IEEE P802.15
Wireless Personal Area Networks

Project	IEEE P802.15 Working Group for Wireless Personal Area Networks (WPANs)	
Title	TG3 Rolling Meadows Ad-Hoc Working Document	
Date Submitted	[9 October, 2001]	
Source	[James P. K. Gilb] [Mobilian] [11031 Via Frontera, Suite C]	Voice: [858-451-2201] Fax: [858-451-3201] E-mail: [gilb@ieee.org]
Re:	[]	
Abstract	[This document is contains the issues and resolutions developed by the TG3 subcommittee at the Rolling Meadows ad-hoc meeting. It also contains additions made to the draft standard D07 to produce D08.]	
Purpose	[To provide a record of the resolutions of TG3 and the changes made to draft standard D07 to produce D08.]	
Notice	This document has been prepared to assist the IEEE P802.15. It is offered as a basis for discussion and is not binding on the contributing individual(s) or organization(s). The material in this document is subject to change in form and content after further study. The contributor(s) reserve(s) the right to add, amend or withdraw material contained herein.

Figure 3—CTA assignment sequence for pseudo-static GTSs

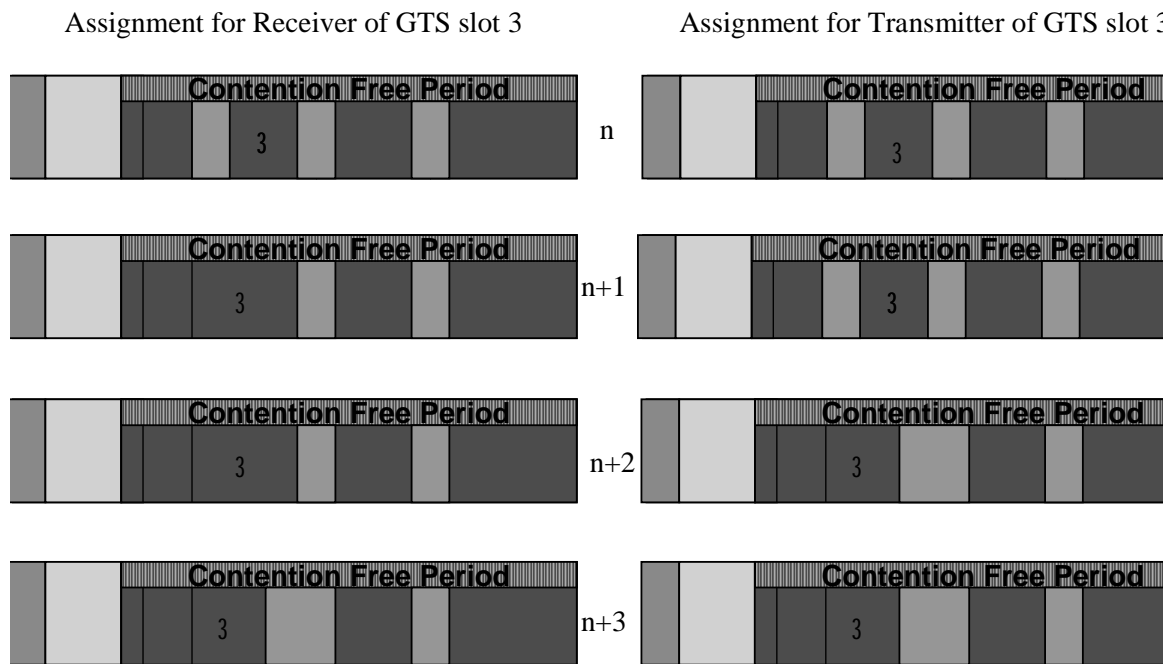
Pseudo static GTSs can be moved by the PNC, but the PNC must notify the affected DEVs by sending them acknowledged Channel Time Grant frames with the new CTA. As with dynamic GTSs, the PNC can rearrange pseudo static GTSs so that the GTS assignments can be optimized, but it must use the Channel Time Grant and coordinate the channel time grants with the CTAs in the beacon.

Before a pseudo static GTS is moved, the PNC shall ensure that the new position is unoccupied by another GTS. Then, the PNC sends a directed channel time grant to the receiving DEV so that the receiving DEV is listening to both the old GTS position and the new position. This channel time grant contains both the old and the new CTA. If the old and the new position overlap, the CTA can be one larger CTA.

Next the PNC sends a channel time grant to the transmitting DEV that contains only the new CTA. By moving the receiver first, the PNC ensures that no frames are lost if Channel time requests are corrupted.

Lastly, the PNC sends a channel time grant to the receiving DEV which only contains the new CTA.

Pseudo-static GTSs may be moved by the PNC, but the PNC needs to notify the affected DEVs by sending channel time grant frames, 7.5.5.2, with the new CTA. As with dynamic GTSs, the PNC may rearrange pseudo static GTSs so that the GTS assignments will be optimized, but it must use the channel time grant command and coordinate the channel time grants with the CTAs in the beacon.

Before a pseudo static GTS is moved, the PNC shall ensure that the new position is unoccupied by another GTS. Then, the PNC shall send a directed channel time grant to the receiving DEV so that the receiving DEV is listening to both the old GTS position and the new position. The channel time grant shall be acknowledged with an Imm-ACK by the DEV if it is received correctly. If the PNC does not receive an Imm-ACK, it may re-send the channel time grant command, but it shall not continue with the process until the acknowledgement is received. The channel time grant sent by the PNC to the receiving DEV contains both the old and the new CTA. If the old and the new position overlap, the CTA may be one larger CTA.

The PNC shall then send a channel time grant to the transmitting DEV that contains only the new CTA. The transmitting DEV shall acknowledge with an Imm-ACK if it is received correctly. If the PNC does not receive the Imm-ACK, it may re-send the channel time grant command, but it shall not move the pseudo-static GTS until the acknowledgement is received. By moving the receiver first, the PNC ensures that no frames are lost if channel time requests are corrupted.

Finally, the PNC shall send a channel time grant to the receiving DEV which only contains the new CTA. The receiving DEV shall acknowledge this command with an Imm-ACK if it is received correctly. If the PNC does not correctly receive the acknowledgement, it may re-send the channel time grant command. However, the PNC may re-allocate the original pseudo-static GTS even if it does not receive the acknowledgement to the command.

Throughout the process, the PNC will ensure that the beacon contains the current CTAs for the pseudo-static GTS that it is moving.

A graphical illustration of the procedure for moving a pseudo-static GTS is illustrated in Figure 3
